Submitted by the experts from The International Automotive
Lighting and Light-Signalling Expert Group (GTB)

Informal document **GRE-90-16**
(90th GRE, 29 April to 3 May 2024,
agenda item 11 (c))

**Draft proposal to amend UN Regulations Nos. 48 and 148 to
introduce Signal Road Projection**

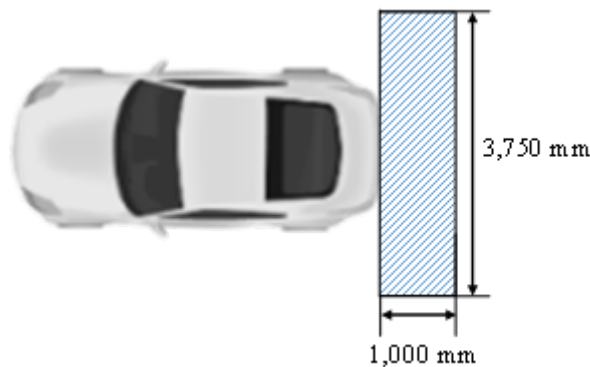
6.27.5.2. The patterns of the reversing projections shall start with their closest edge within a rectangle, symmetrical to the median longitudinal plane and adjacent to the extreme outer edge of the vehicle a width of 1,000 mm and a length of 3,750 mm.

6.28.5. Projection area

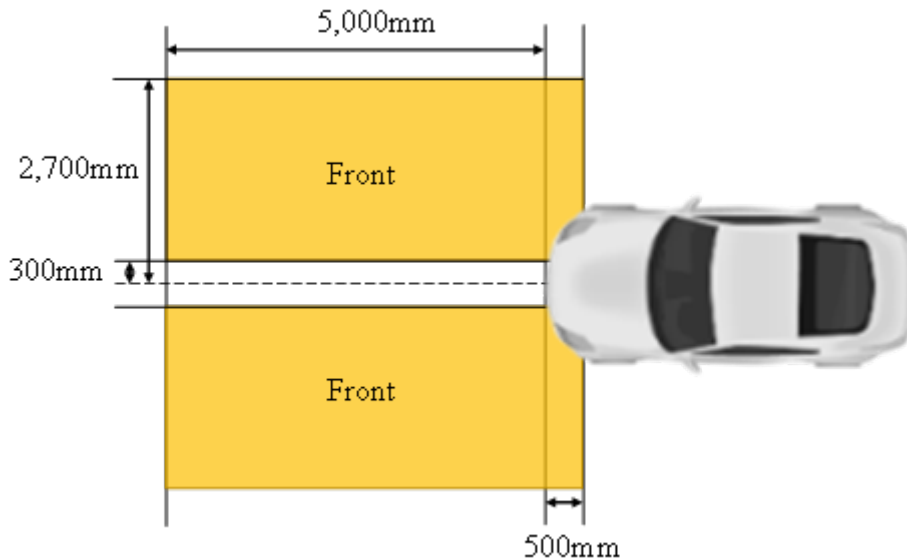
6.28.5.1. Front direction indicator projection

The lateral distance from the outer edge of the projection with respect to the longitudinal plane of the vehicle shall not be more than 2,700 mm.

The longitudinal distance from the farthest edge of the projection shall not be more than 5,000 mm from the forward extreme outer edge of the vehicle and the rearward edge of the projection shall be not more than 500 mm rearward of the forward extreme outer edge of the vehicle.

The inner boundary of the projection area is limited by a minimum distance of 300 mm from the longitudinal centre line of the vehicle (see figure below).

6.28.5.2. Rear direction indicator projection

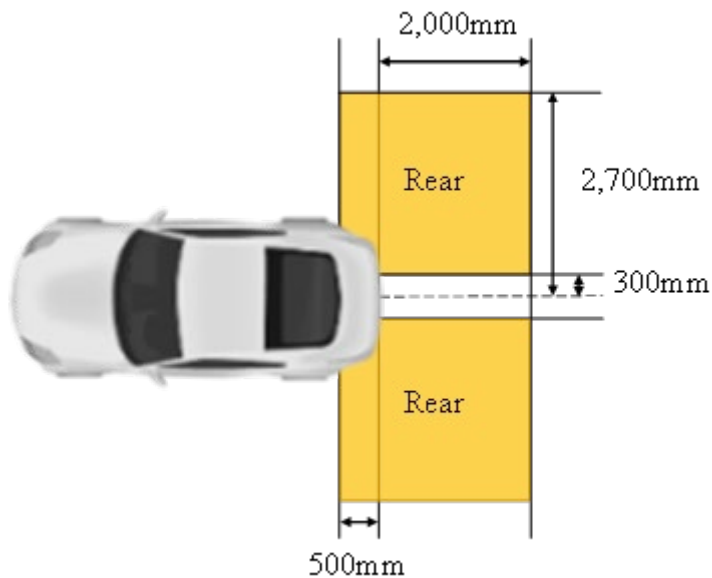
The lateral distance from the outer edge of the projection with respect to the longitudinal plane of the vehicle shall not be more than 2,700 mm.

The longitudinal distance from the rearmost edge of the projection shall not be more than 2,000 mm from the rearward extreme outer edge of the vehicle and the forward edge of the projection shall be not more than 500mm forward of the rearward extreme outer edge of the vehicle.

The inner boundary of the projection area is limited by a minimum distance of 300 mm from the longitudinal centre line of the vehicle (see figure below).

6.28.5.3. Side direction indicator projection

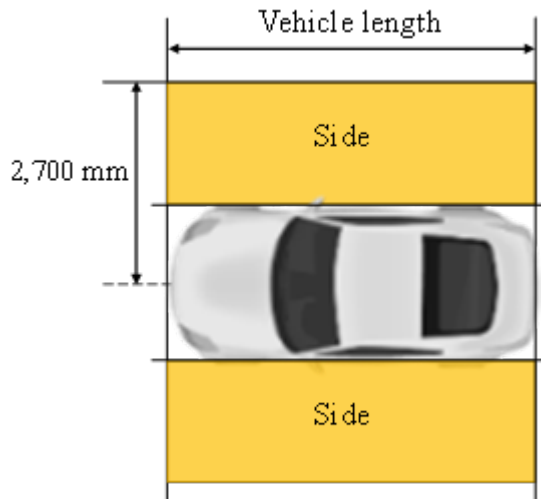
The lateral distance from the outer edge of the projection with respect to the longitudinal plane of the vehicle shall not be more than 2,700 mm.

In length, the projection area is limited by the vehicle length (see figure below)

6.28.5.4. The patterns of each front direction indicator projection shall start with their closest edge within a zone limited by:

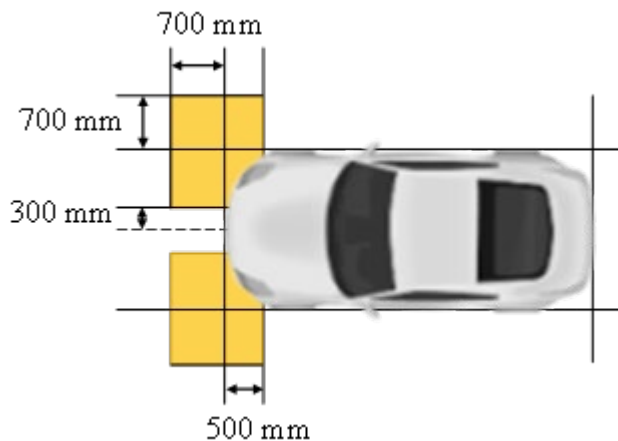
- a transverse plane 700 mm forwards of the front extreme outer edge of the vehicle,
- a transverse plane 500 mm rearwards of the front extreme outer edge of the vehicle,
- a longitudinal plane 700 mm outwards from the side extreme outer edge of the vehicle and
- a longitudinal plane 300 mm from the longitudinal median plane of the vehicle (see figure below)

6.28.5.5. The patterns of each rear direction indicator projection shall start with their closest edge within a zone limited by:

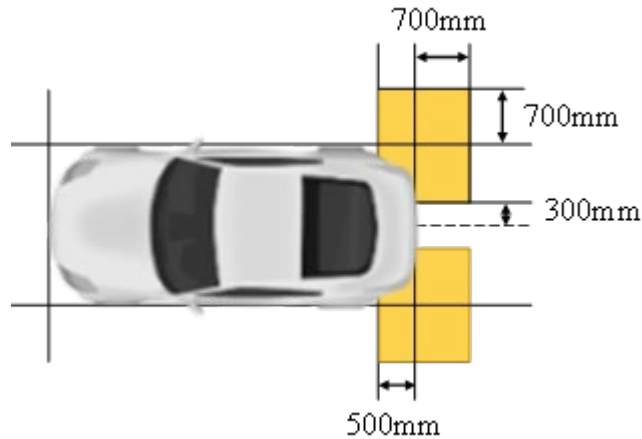
- a transverse plane 700 mm rearwards of the rear extreme outer edge of the vehicle,
- a transverse plane 500 mm forwards of the rear extreme outer edge of the vehicle,
- a longitudinal plane 700 mm outwards from the side extreme outer edge of the vehicle and
- a longitudinal plane 300 mm from the longitudinal median plane of the vehicle (see figure below)

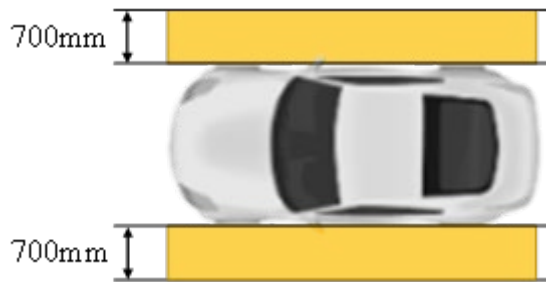
- 6.28.5.6.** The patterns of each side direction indicator projection shall start with their closest edge within a zone limited by:
- a transverse plane at the front extreme outer edge of the vehicle,
 - a transverse plane at the rear extreme outer edge of the vehicle and
 - a longitudinal plane 700 mm outwards from the side extreme outer edge (see figure below)
